# Access Compliance Report

## Public Rights-of-Way

### (Curb Ramps)

Intersection ID: 25924	Main Street: BAYBROOK_LN	Cross Street: WOODLEIGH_OAKS_DR	Location: SE
ADA ID: B299A6CFB052	Ramp Type: PerpDiag	Initial Pass/Fail: Fail	Overall Compliance: No
Severity Score: 21.25			
Codes/Mitigation Info/Possible Solution		Field Measurements/Component Compliance

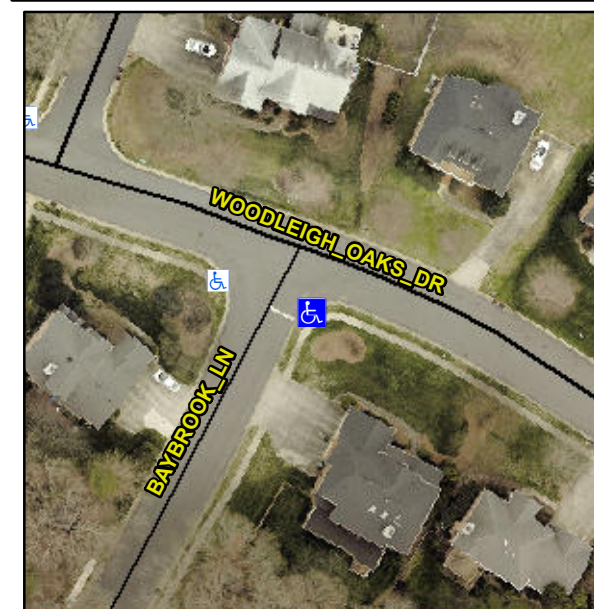
**Not Found, R304.5.1, R304.5.3**

Compliance	Description	Data	Compliance	Description	Data
N/A	Ramp Length (in)	94.0	Yes	Ramp Slope (%)	6.7
No	Ramp Width (in)	43.5	No	Ramp XSlope (%)	5.2
N/A	Flare Type LT	N/A	N/A	Flare Type RT	N/A
N/A	Flare Slope LT (%)	N/A	N/A	Flare Slope RT (%)	N/A
N/A	Flare Traversable LT?	N/A	N/A	Flare Traversable RT?	N/A
N/A	Landing Length (in)	N/A	N/A	DWS Provided?	N/A
N/A	Landing Width (in)	N/A	N/A	DWS Contrast?	N/A
N/A	Landing Slope (%)	N/A	N/A	DWS Length (in)	N/A
N/A	Landing X Slope (%)	N/A	N/A	DWS Full Width?	N/A
N/A	Landing Curb? (Y/N)	N/A	N/A	DWS Offset (in)	N/A
N/A	Shared Landing?	N/A			
N/A	Gutter Ponding?	N/A	N/A	Gutter Slope (%)	N/A
N/A	Gutter Lip Ht (in)	N/A	N/A	Gutter X Slope (%)	N/A
N/A	Painted X Walk1?	No	N/A	Painted X Walk2?	No
	X Walk 1 Direction	To NE		X Walk 2 Direction	To NW
N/A	X Walk 1 Width (in)	N/A	N/A	X Walk 2 Width (in)	N/A
	X Walk 1 Slope (%)	4.4		X Walk 2 Slope (%)	0.8
	X Walk 1 X Slope (%)	0.7		X Walk 2 X Slope (%)	3.6

**Remove & Replace Curb Ramp With Two New Directional Ramps or Equivalent.**
